**IMPORTANT MEDICAL DEVICE SAFETY ALERT****Medtronic HeartWare™ HVAD™ System**

Product	Models
HVAD™ Pump Outflow Graft	1125
HVAD™ Pump Implant Kit	1103
HVAD™ Implant Accessories Kit	1153

April 2020

**Appendix A: Outflow Graft Attachment excerpts from IFU (standard text) and Additional Steps (italicized underlined text)**

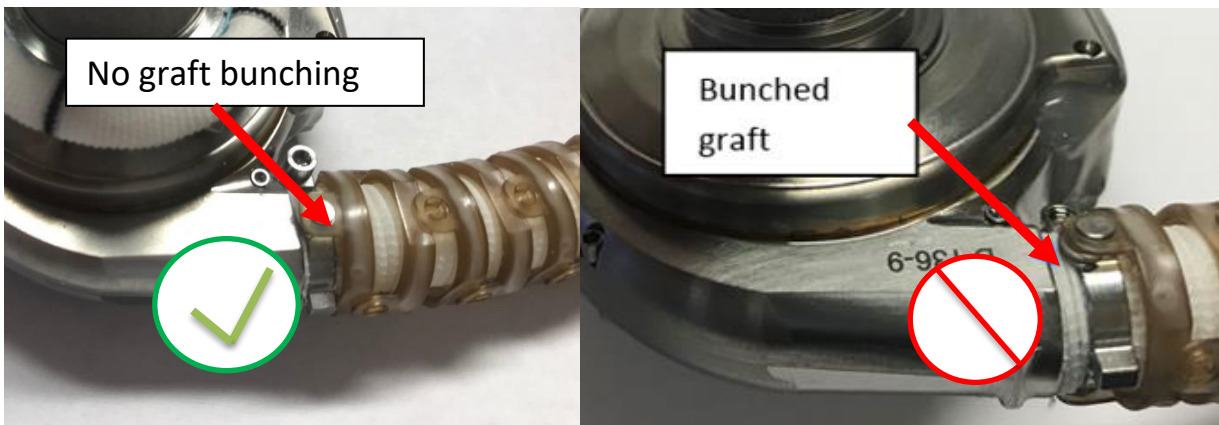
Avoid "bunching" of graft corrugations between the strain relief clamp and the pump body.

While maintaining the fully loosened strain relief clamp over the pump outflow conduit, gently pull on the outflow graft to reduce corrugation bunching between clamp and pump body. Extra corrugations from the graft may prevent the strain relief clamp from being flush against the pump body, leading to the strain relief clamp being positioned over the pump outflow conduit ridge, potentially resulting in graft laceration while tightening.
